Form 3160-5 (June 2019)	UNITED STATES DEPARTMENT OF THE INTERIOR BUREAU OF LAND MANAGEMENT	FORM APPROVED OMB No. 1004-0137 Expires: October 31, 2021
SUNDRY NOTICES AND REPORTS ON WELLS <i>Do not use this form for proposals to drill or to re-enter an abandoned well. Use Form 3160-3 (APD) for such proposals.</i>		5. Lease Serial No. NMNM093207
		6. If Indian, Allottee or Tribe Name

EOG respectfully requests an amendment to our approved APD for this well to reflect the following changes:

Midnight Hour 11 Fed Com 712H API #: 30-015-53292

WELL LOCATION AND ACREAGE DEDICATION PLAT

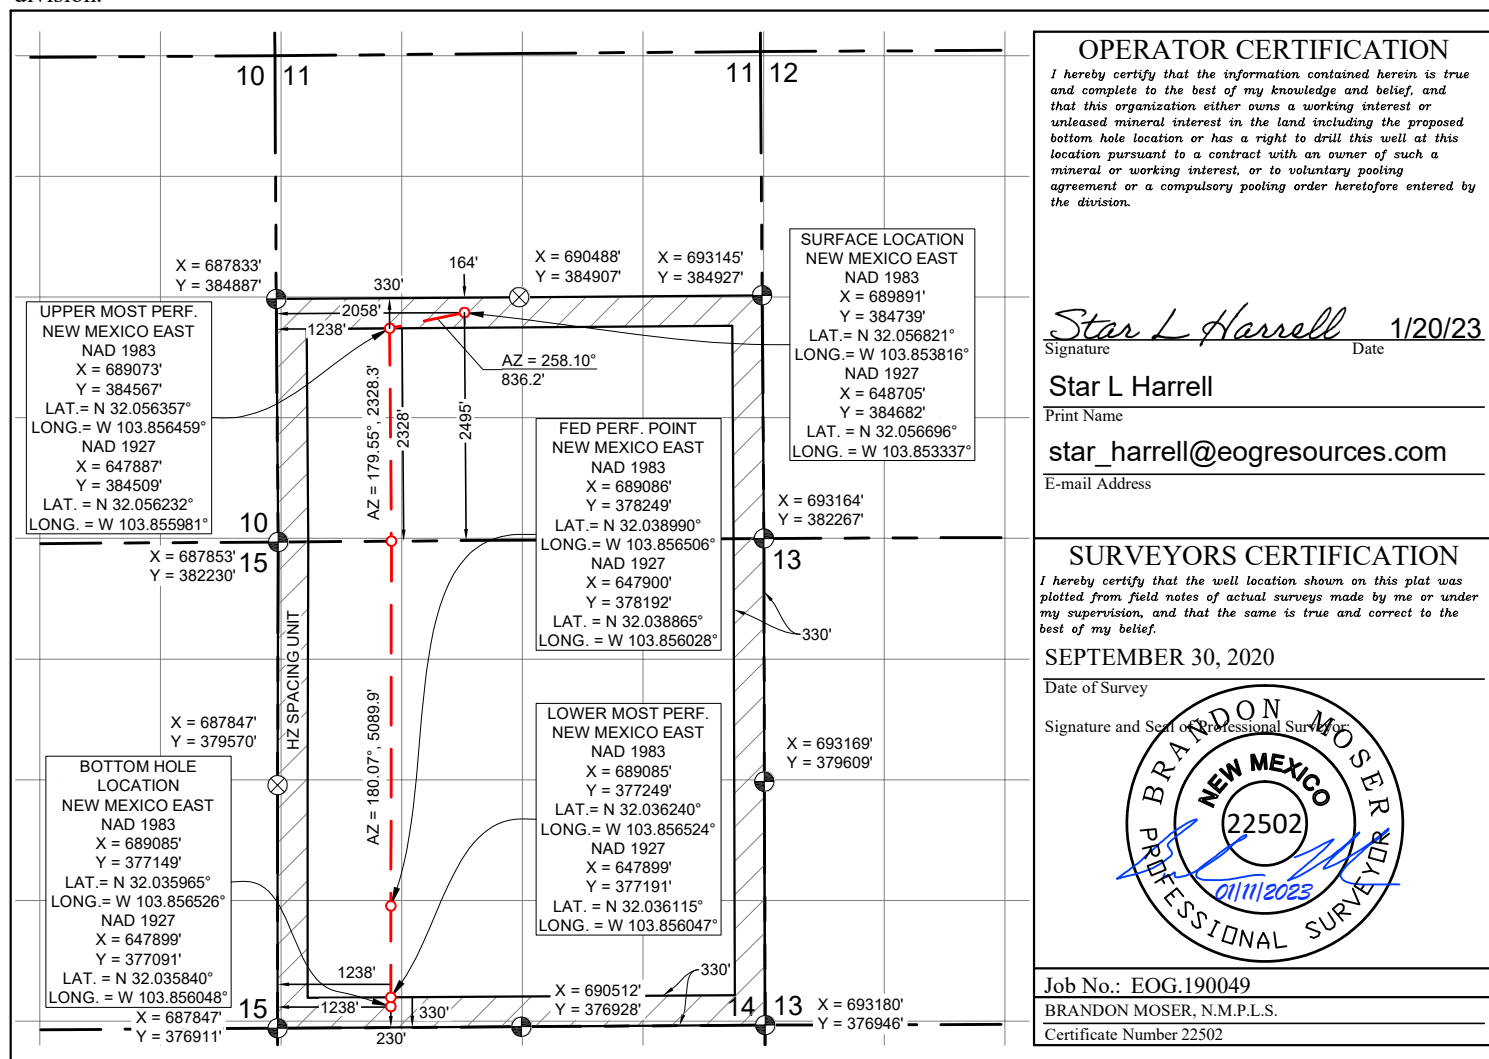
Change BHL from T-26-S, R-30-E, Sec 14, 230' FSL, 1310' FWL, Eddy Co., NM, to T-26-S, R-30-E, Sec 14, 230' FSL, 1238' FWL, Eddy Co., N.M.

UL or lot no.	Section	Township	Range	Lot Idn	Feet from the	North/South line	Feet from the	East/West line	County
M	14	26 S	30 E		230	SOUTH	1238	WEST	EDDY

Revised Wellbore

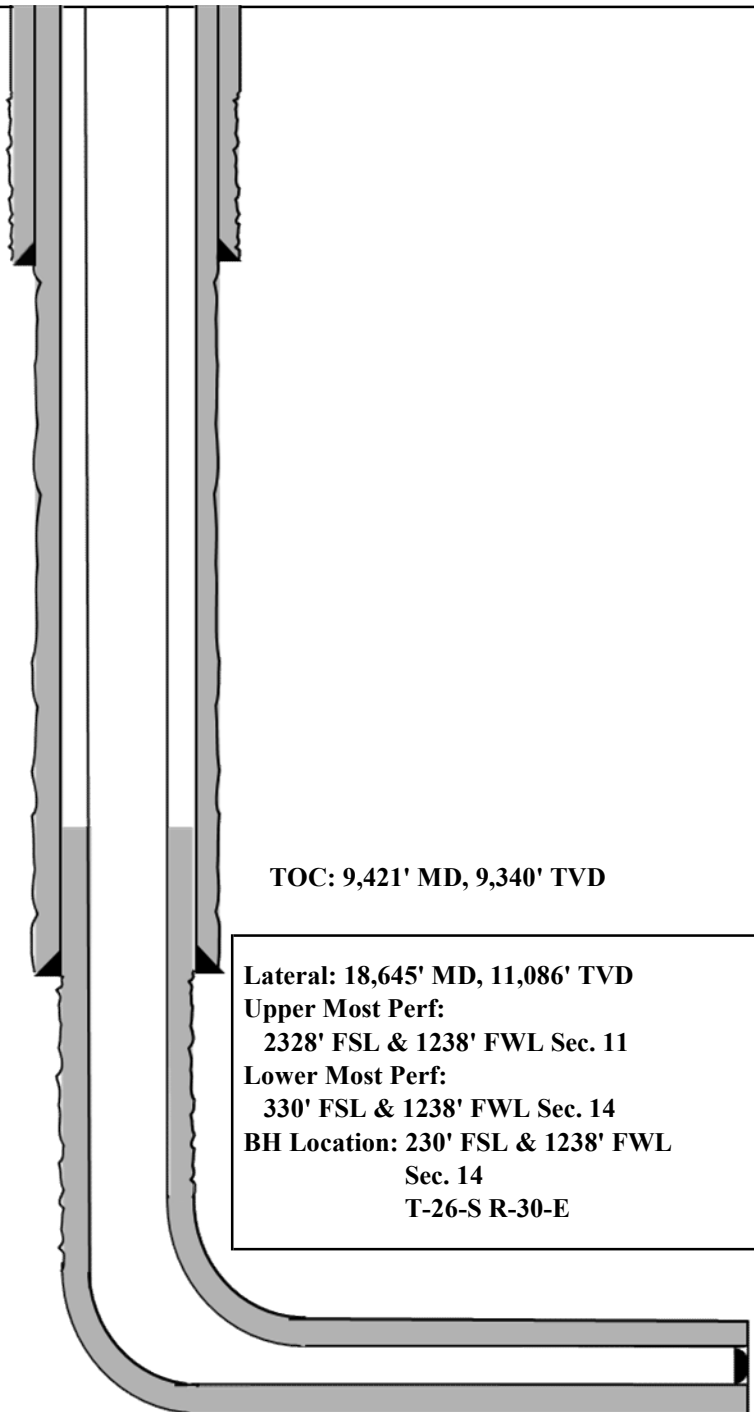
Update casing and cement program to current design.

Bit Size: 12-1/4"
9-5/8", 36#, J-55, LTC,
@ 0' - 1,160'

Bit Size: 8-3/4"
7-5/8", 29.7#, HCP-110, FXL,
@ 0' - 9,921'

Bit Size: 6-3/4"
5-1/2", 20#, P110-EC, DWC/C IS MS,
@ 0' - 9,421'

5-1/2", 20#, P110-EC, Vam Sprint SF,
@ 9,421' - 9,921'

5-1/2", 20#, P110-EC, DWC/C IS MS,
@ 9,921' - 18,645'
